ADDENDUM NO. 1

MARTIN LUTHER KING JR. COMMUNITY CENTER ROOF REPAIR / ITB 17-010

Dr. Martin Luther King Jr. Memorial Community Center – Roof renovation

Pre-Bid Request for Information:

S-2

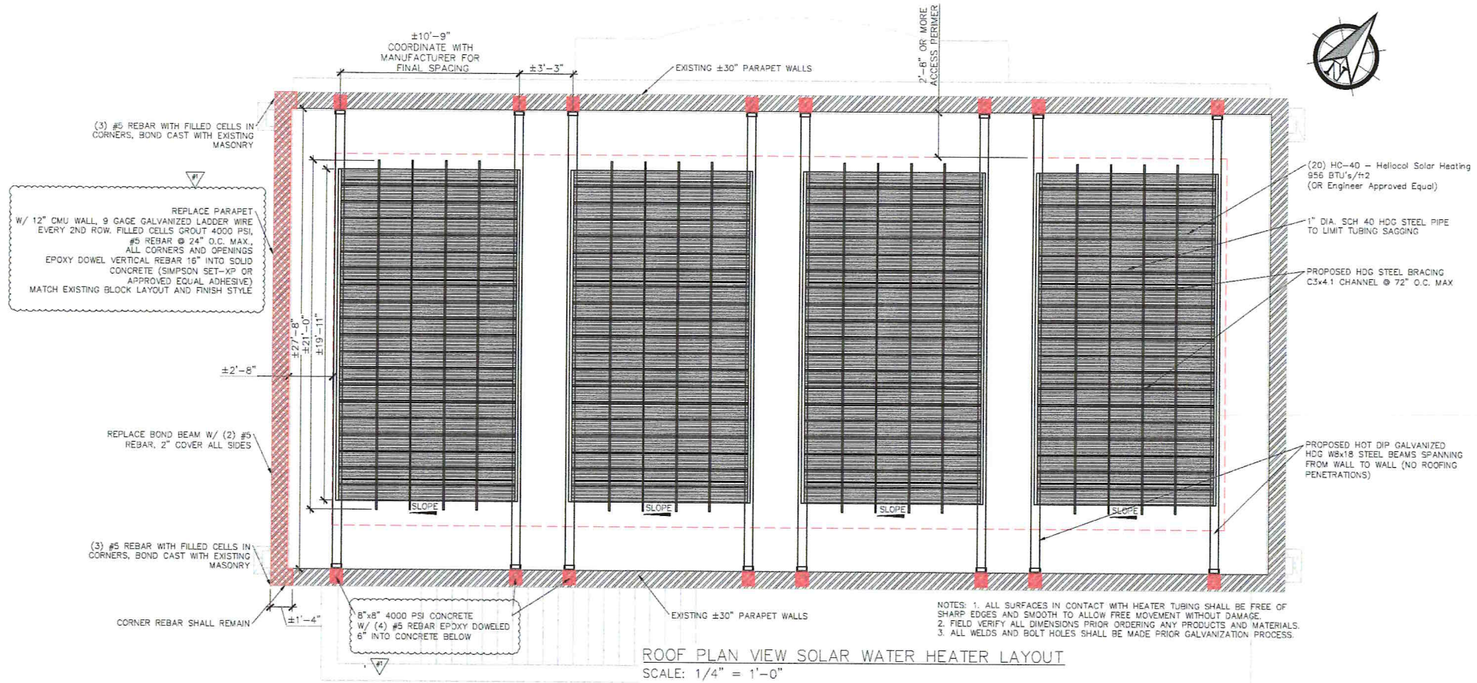
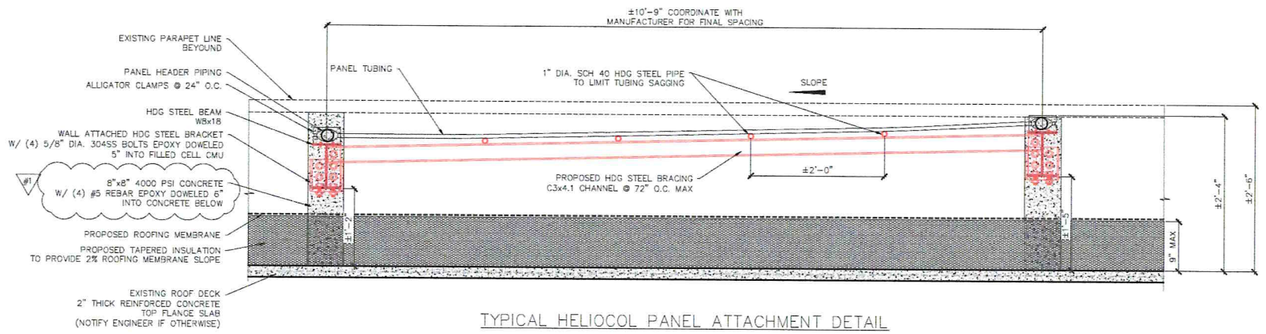
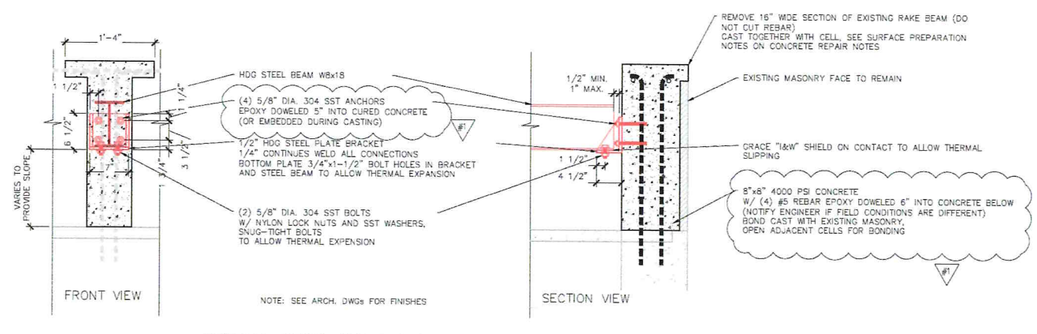
b) The drawings do not have any "***engineered details"*** on how to repairs Concrete spalling in the parapet masonry and rake beams. Please provide if this part of this RFP.

4) At the pre-bid meeting, it was observed that the existing parapet wall that will be demolished was 12" wide and new replacement wall is 8" wide according to drawings S-2. Please verify if this new all will still be built 8" wide? This will affect the roofer and the coping ect.

Response: The parapet shall be replaced as shown and described on sheet S-2 of the construction drawings.

Response: The new parapet wall is to be the same width as the existing 12" wall. The contractor shall field verify CMU block sizes upon the demolition of parapet coping and roofing membrane and match existing if different from 12" wide block.
